Marin County Flood Control and Water
Conservation District
**Corte Madera Creek Flood Risk Management
Project, Phase 1**
Final Environmental Impact Report
Volume 1: Comments and Responses to Comments
State Clearinghouse No. 2020080353

**Marin County Flood Control and Water
Conservation District
Corte Madera Creek Flood Risk Management
Project, Phase 1
Final Environmental Impact Report
Volume 1: Comments and Responses to Comments
State Clearinghouse No. 2020080353**

Figure 3.15-1 Utilities and Service Systems in the Project Area (Map 1 of 3)

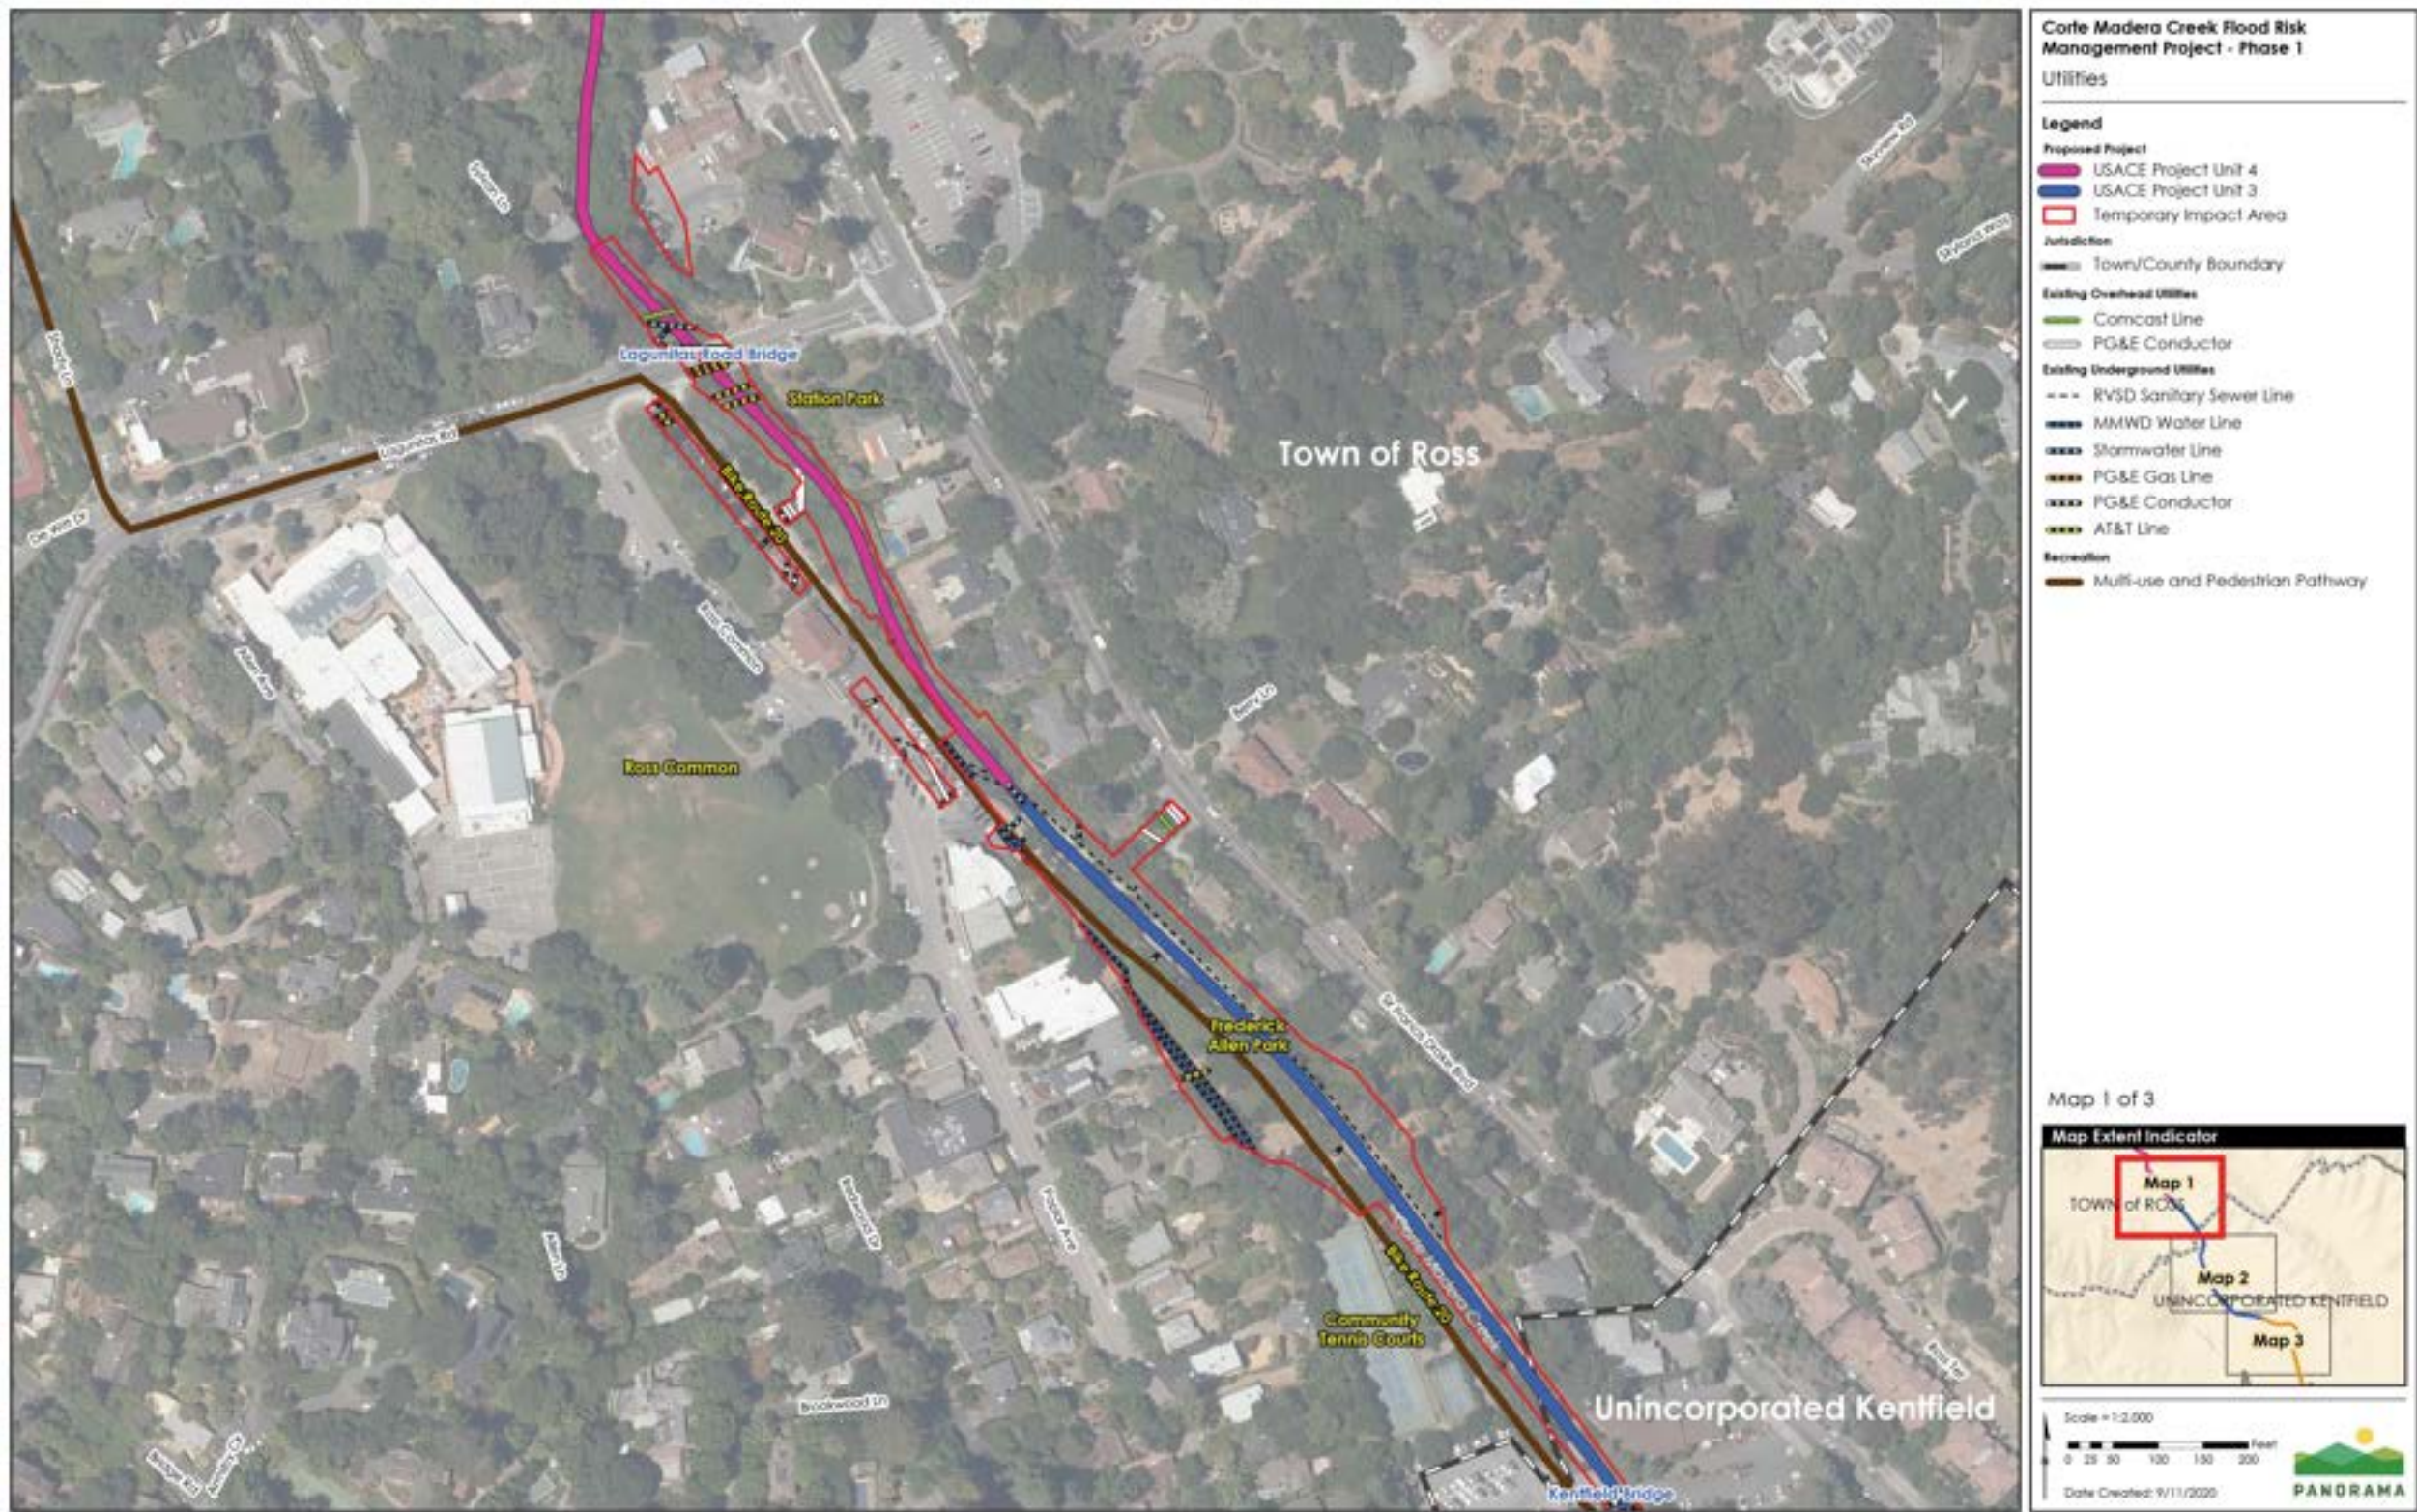
The first full paragraph on page 3.15-2 states: "An aboveground sewer pipe crosses the creek on the pedestrian bridge at the end of Stadium Way (Figure 3.15-3)." The sewer is a deeply buried pipeline that crosses the creek in an inverted siphon. The aboveground pipeline is a water distribution line.

The legend refers to MMWD stormwater lines. This is inaccurate: MMWD supplies treated domestic water; towns and the District are responsible for stormwater. The Design Basis Report (GDG 2020) describes utilities in the Lower COM project area, most of which are not shown accurately on Figure 3.15-3. Also, the outline of the Lower COM project area is inaccurate. It shows two areas that should be removed from the figure: the inaccurate staging area and an area on the left bank that has since removed from the project. Please use the most recent 65% designs.

In response to comments B1-25 and B1-51, Figures 3.15-1, 3.15-2, and 3.15-3 in the Draft EIR (pages 3.15-3, 3.15-4, and 3.15-5) have been revised as follows:
